# VVTA IFB 2019-10 ELECTRIC BUS WRAPS ADDENDUM NO. 1

This addendum is provided to all known prospective proposers for clarification of the subject Invitation for Bid (IFB).

DRAWING NO  
648972

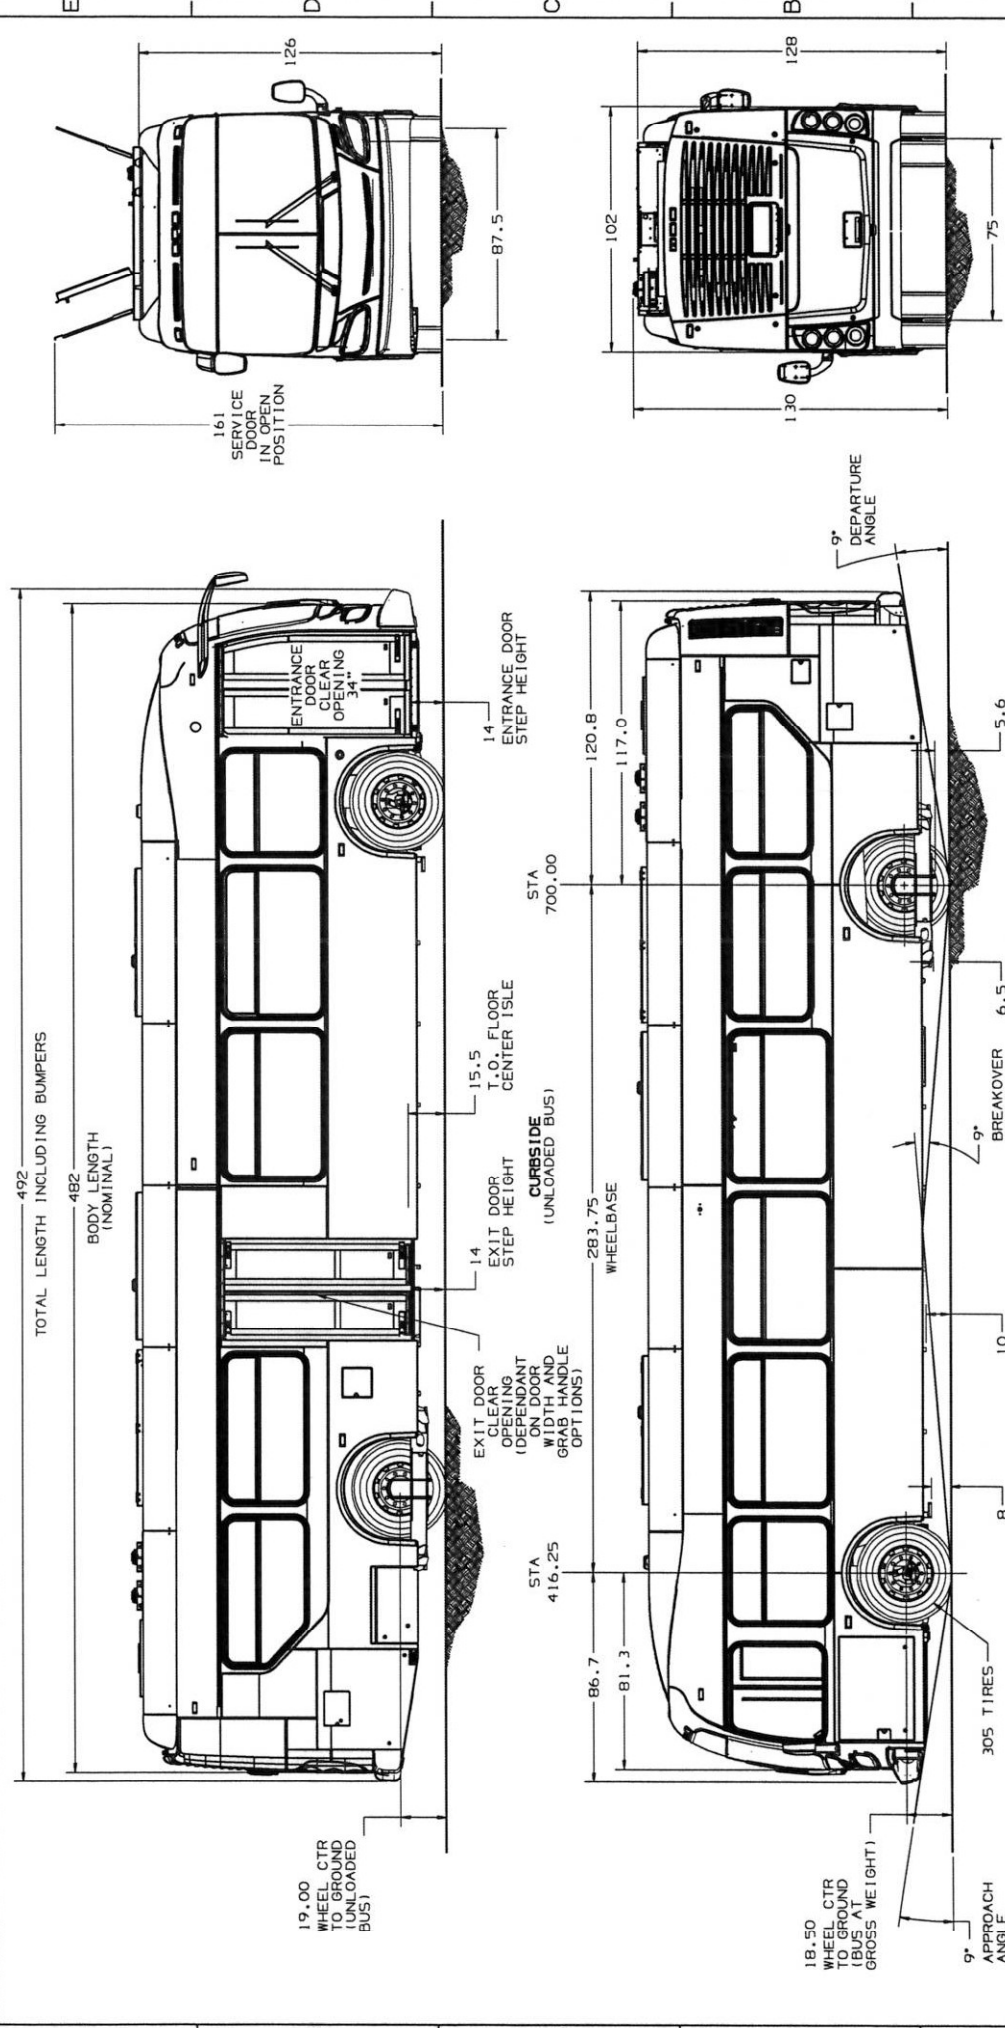
Q2: "Please let me know if you are able to give us a rendering of the buses and/or a picture of them?"

Q8: "It looks from the design enclosed that window coverage needed for these wraps. If so, are there any restrictions to the amount of window coverage or are they fully covered? I'm assuming the windows will be covered in perforated window film, correct? Or is there another material specified?"

Q13: "Will manufacturer's templates of the buses be made available for help in producing the graphic? Or are the graphics print-ready as is confirming to the manufacturer's template?"

Q36: "The design shows the front passenger door is covered. Is this correct?"

Q38: "Can we get a copy of the elevation drawings and measurements?"

A2: Please see Attachment 1 to this addendum. The manufacturer has provided an elevation drawing with measurements. Also, this link includes photos of the buses:  
<https://www.newflyer.com/buses/xcelsior-charge/>.

A8: The windows need to be covered in film similar to 40% perforated window film. Driver's view from the bus not be inhibited in any way.

A13: Attachment 1 – includes the Elevation and measurements of the bus. '

A36: Front passenger door windows will not be covered.

A38: These drawings are included as Attachment 1 to this Addendum.
